# SERVICE BULLETIN

Subject: Allison Shift Selector Monitor  
Harness Improvement

Bulletin No: TS30-FC-2601

Vehicle Model: TS30

Transition Sockets and Fuse&Relay Panel Location:

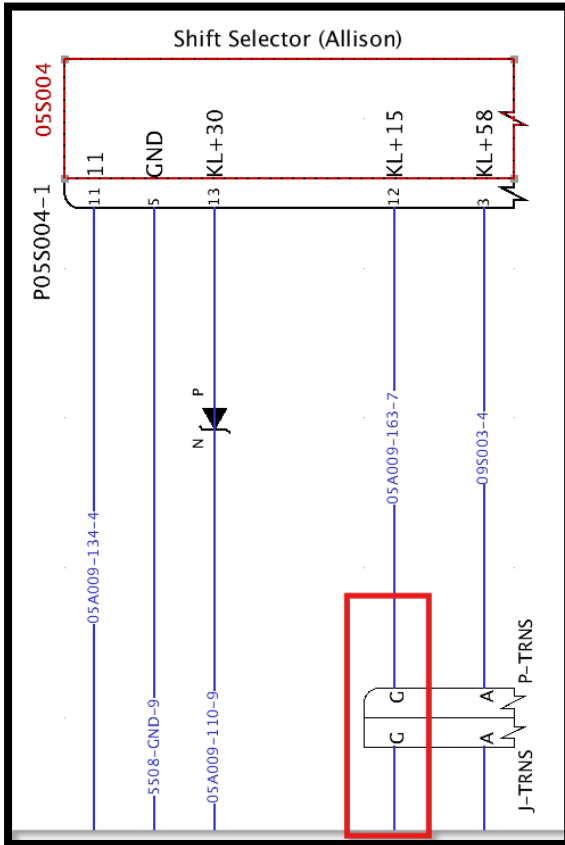
1. In the area where the relay panel transition sockets are located, find socket labeled P-TRNS.
2. The cable (05A009-163-7) connected to pin G of socket P-TRNS will be cut 10 cm from the point of connection.

3. Insert terminal numbered 9402-81Y into the cable remaining on the P-TRNS socket side of the cut cable.
4. Connect the terminated cable to pin 1 of the waterproof male connector numbered 9460-549.
5. Insert terminal numbered 9402-81Y into the other end of the cut cable.
6. Connect the terminated cable to pin 2 of the waterproof male connector numbered 9460-549.

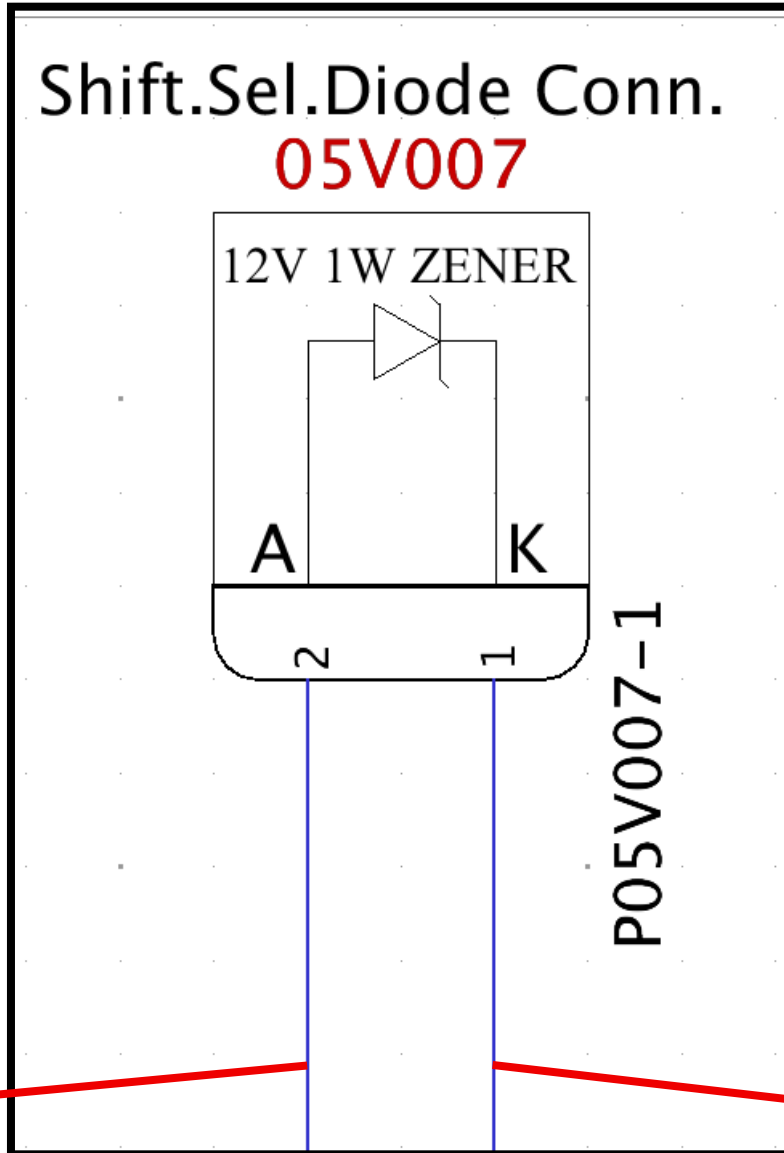
7. A zener diode (9431-07Y) female socket will be inserted into male socket numbered 9460-549. (The direction of the zener diode is indicated in the image below.)

Note: The metal diode leads must be insulated so that they do not come into contact with any point on the outer casing.
